Mae Fah Laung-Chiang Rai International Airport / Aerodrome Ground Movement Chart

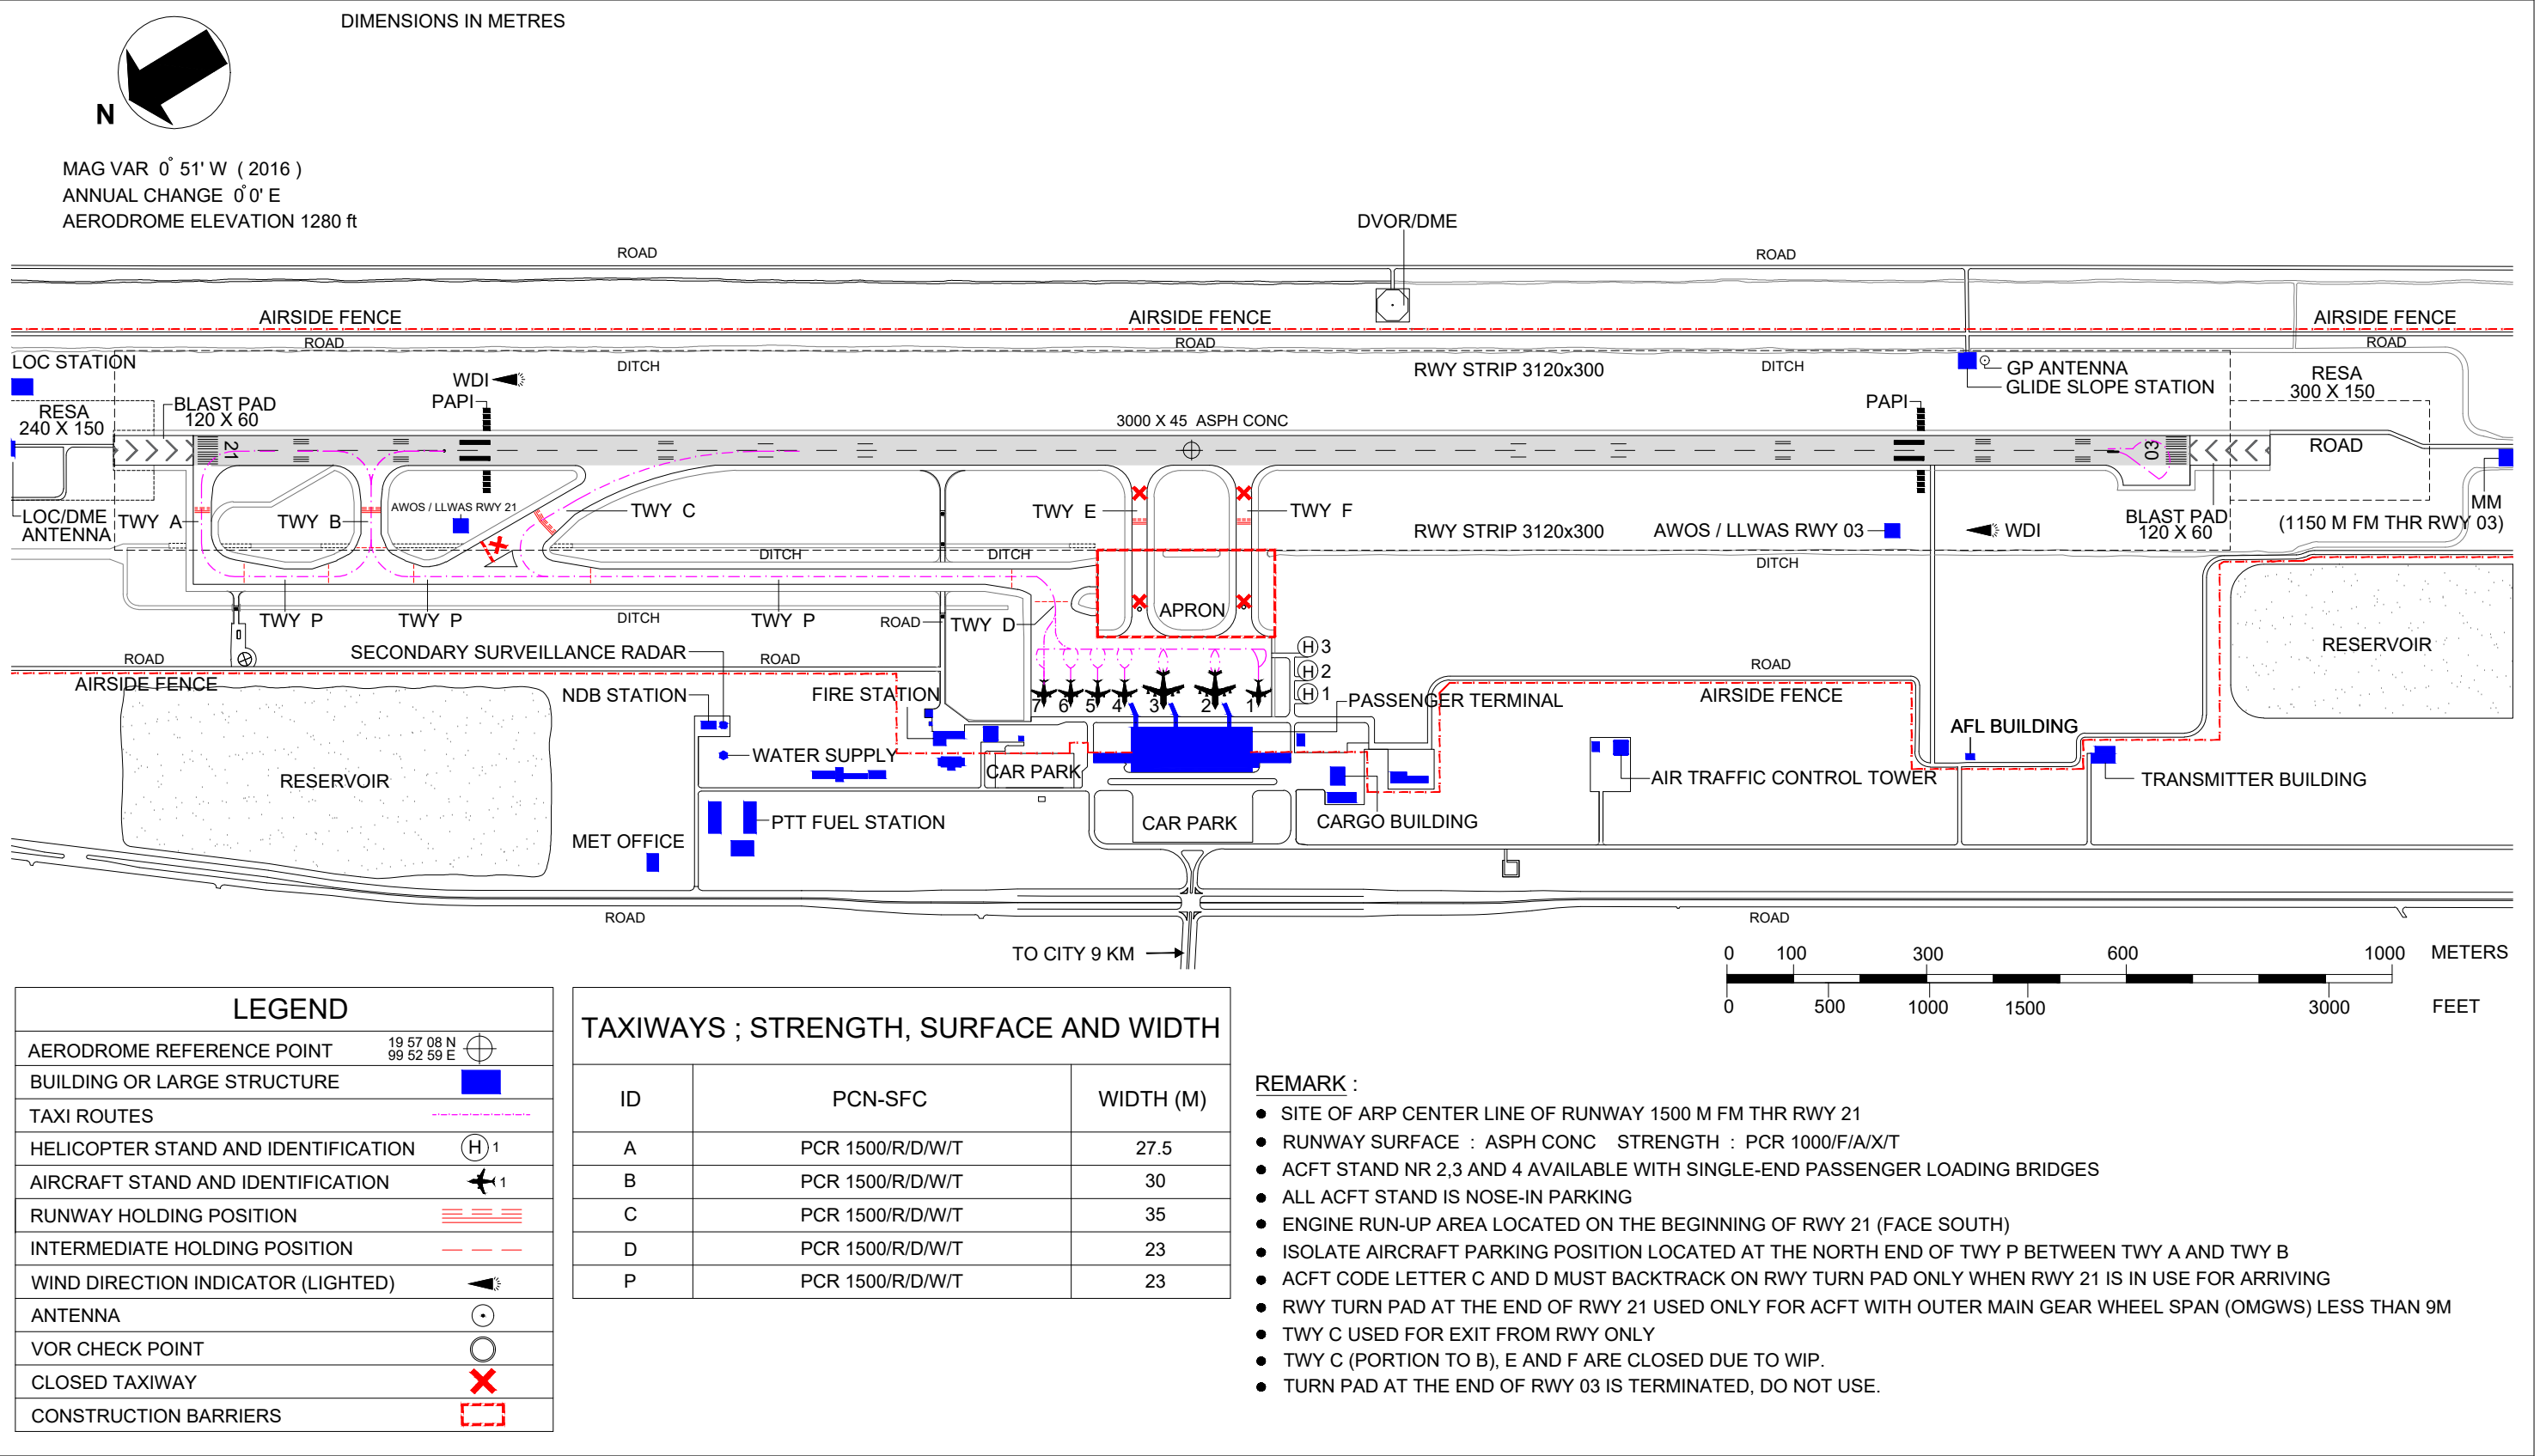
CHANGE : RESA 03 DIMENSION REVISED. SWY 03 CANCELLED. BLAST PAD 21 ADDED. NEW TWY A, TWY B, TWY C, TWY D, TWY P ADDED. FORMER TWY A REVISED NAME AS TWY F. FORMER TWY B REVISED NAME AS TWY E. PCN CHANGED TO PCR
